Re Planning Commission Submittal – Follow Up Information Request from Planning Staff
Butler Street Apartments– Reese and Blake Fisher

Butler Street Apartments

21005.00 – North Butler Street Development – Follow Up Information

Image 1 – Grade Analysis/Determination of Lamp House and Proposed Development

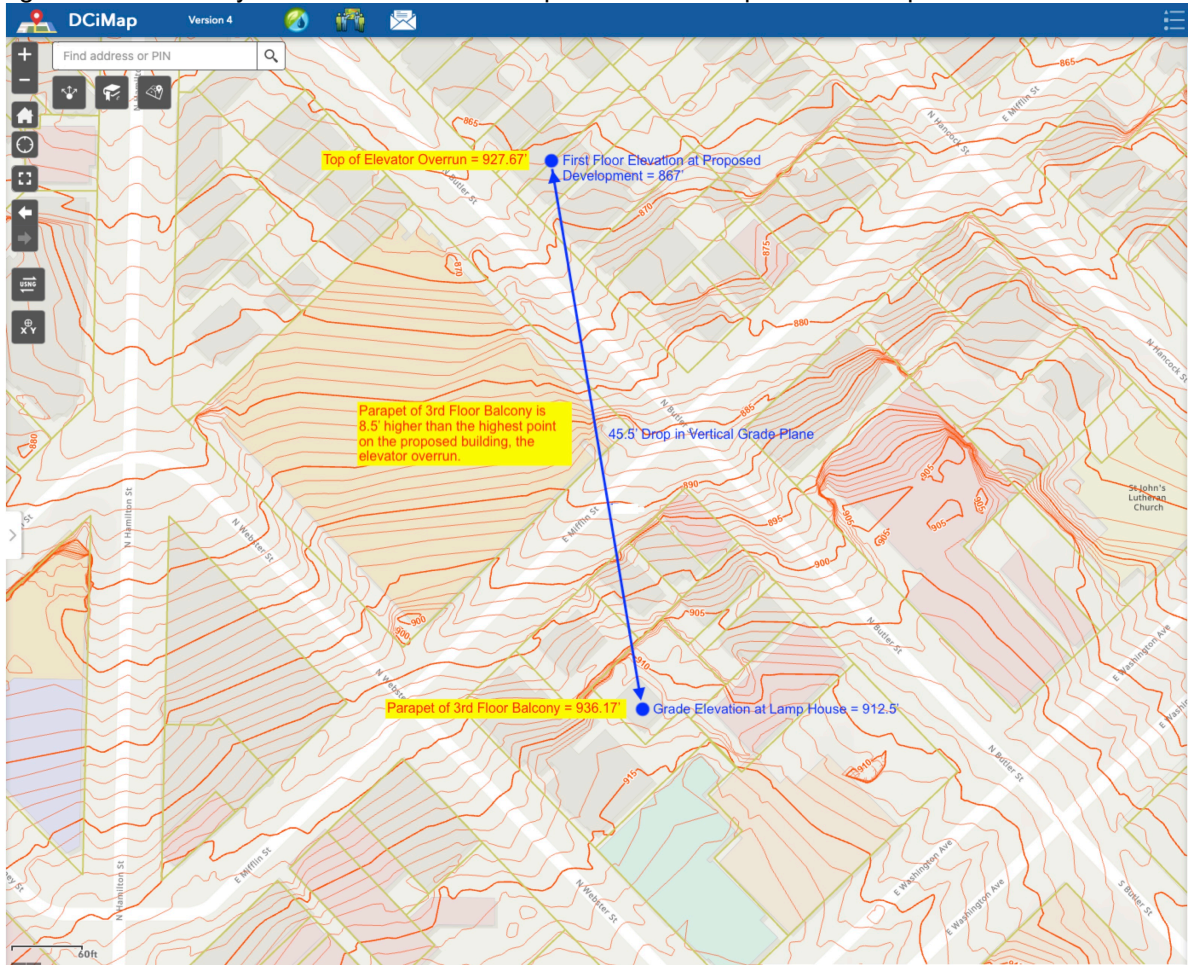
The second item Planning Staff requested was additional information on the study of the impact the proposed project has on views from the Lamp House. Below is an analysis of the proposal's impact based on the electronic 3D file provided by City Staff and that was used as part of the Report of the Lamp House Block Ad Hoc Plan Committee dated January 2014 and adopted as a supplement to the City's Downtown Plan March 2014. The development team has placed the proposed building within that model at the appropriate elevation related to the Lamp House based on data from DCiMap of Dane County that provides existing grading of the area. The diagram below shows that the first-floor elevation of the proposed building is 45.5' below the grade elevation at the Lamp House, and more importantly that the highest point of the proposed building (the elevator overrun) is 8.5' below the parapet of the 3rd floor balcony of the Lamp House. This data has then allowed the team to place the proposed building in the provided model to show that there is no impact to the view to Lake Mendota from the Lamp House. We have also included comparison images from those in the Ad Hoc Plan Committee report to illustrate this condition.
